February 27, 2003

Subject: Duke Energy Corporation  
Catawba Nuclear Station Units 1 & 2, Docket Nos. 50-413, 50-414  
McGuire Nuclear Station Units 1 & 2, Docket Nos. 50-369, 50-370  
Proposed Amendments to the Facility Operating License and Technical  
Specifications to Allow Insertion of Mixed Oxide (MOX) Fuel Lead Assemblies and  
Request for Exemption from Certain Regulations in 10 CFR Part 50

Attachment 1 contains a marked copy of the current McGuire Technical Specifications and associated Bases showing the proposed changes to allow insertion of MOX fuel lead assemblies.

Figure 3.7.15-1 (page 1 of 1)  
Required 3 out of 4 Loading Pattern for Restricted Region 1A Storage

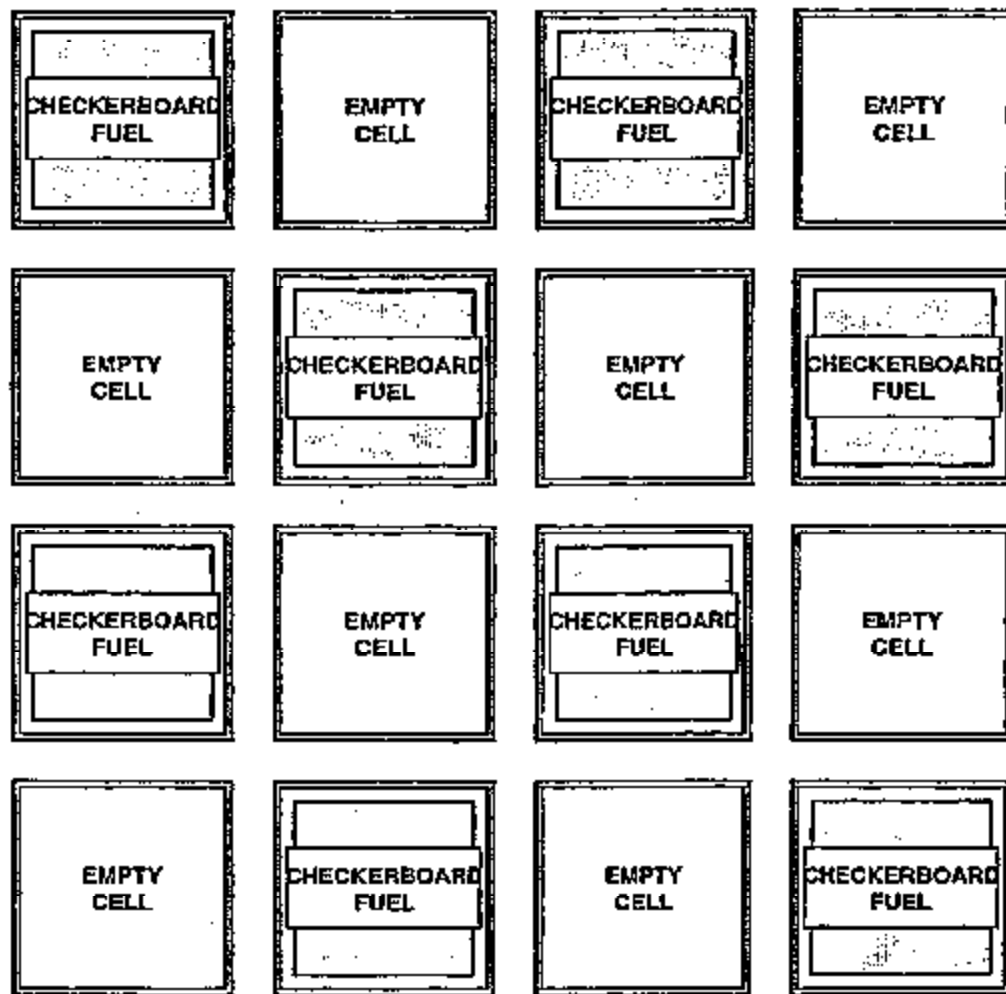
4. Restricted storage, in accordance with Figure 3.7.15-1, of MOX fuel assemblies as Restricted Fuel.

Any Restricted Region 1A Storage Area row bounded by any other storage area shall contain a combination of restricted fuel assemblies and filler locations arranged such that no restricted fuel assemblies are adjacent to each other. Example: In the figure above, row 1 or column 1 can not be adjacent to another storage area, but row 4 or column 4 can be.

Figure 3.7.15-3 (page 1 of 1)  
Required 2 out of 4 Loading Pattern for Checkerboard Region 1B Storage

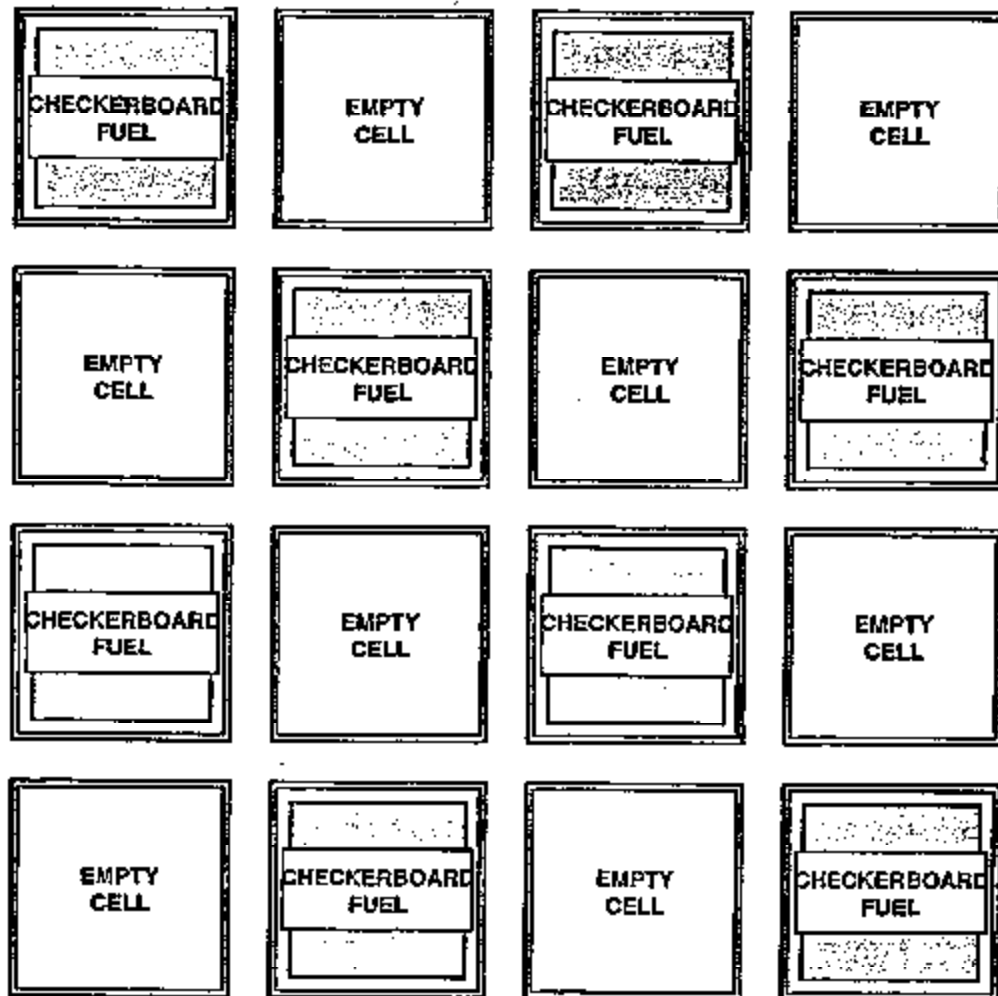
4. Checkerboard storage, in accordance with Figure 3.7.15-3, of MOX fuel assemblies as Checkerboard Fuel.

Fuel which: a) does not meet the minimum burnup requirements of Table 3.7.15-5; or b) is a mixed oxide fuel assembly with a maximum nominal fissile plutonium concentration of 4.15 weight percent and a maximum nominal U-235 enrichment of 0.35 weight percent.
